Affirm[®]

Prone Biopsy System

Customer Release Notes
MAN-06082 Revision 003

For Software Version 1.1

3.3.2 Additional Indicator to Accept/Reject Targets

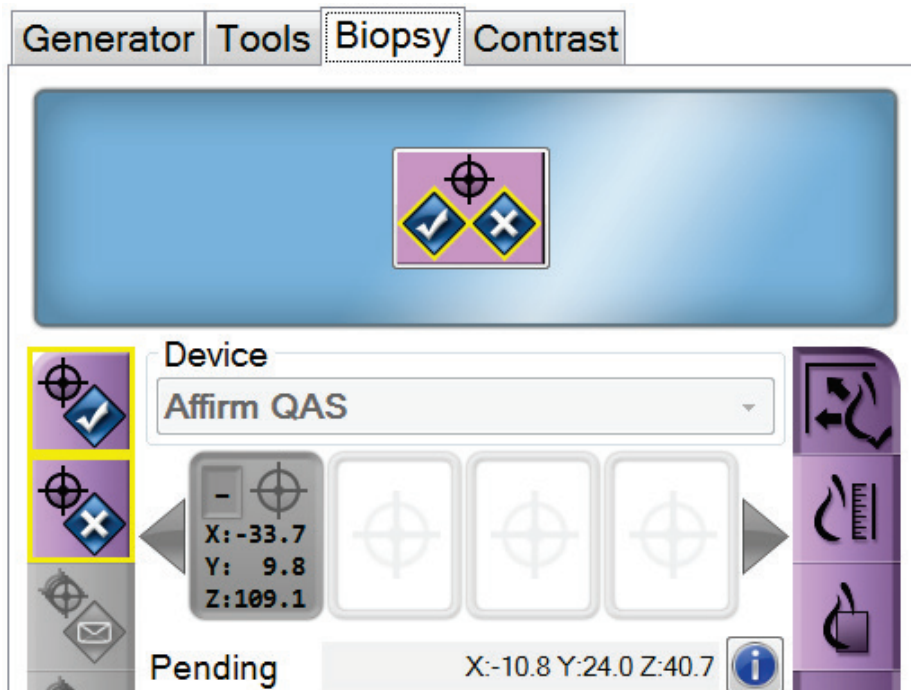
After a biopsy target has been created on the Image Display monitor, the System Messages panel now displays the indicator with a blue background (see the following figure) to alert the operator to Accept or Reject the target.

3.3.6 Warning Displayed When a Target Is Created with a Non-Clinical Needle

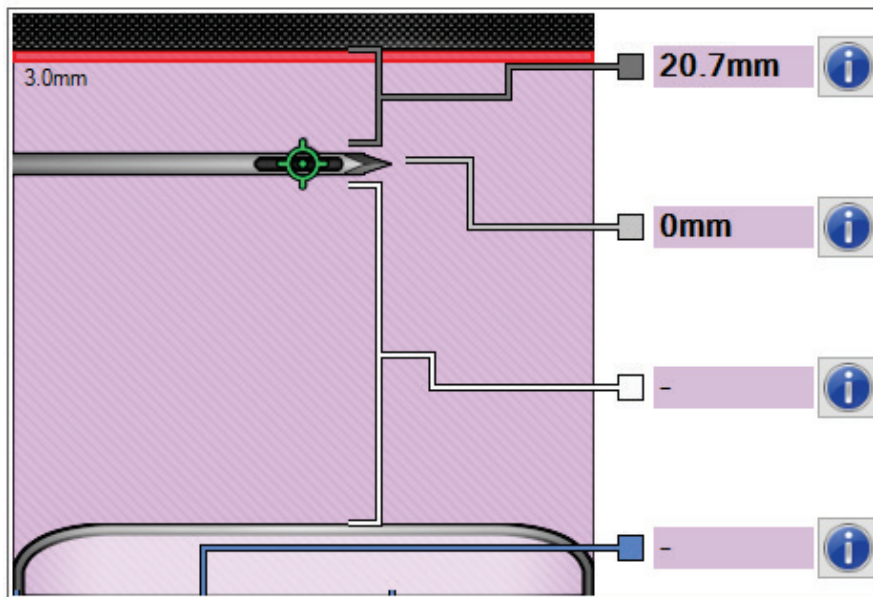
A warning dialog box will now be displayed to the user when a biopsy target is created on a patient image with a non-clinical needle selected (such as the QAS needle).
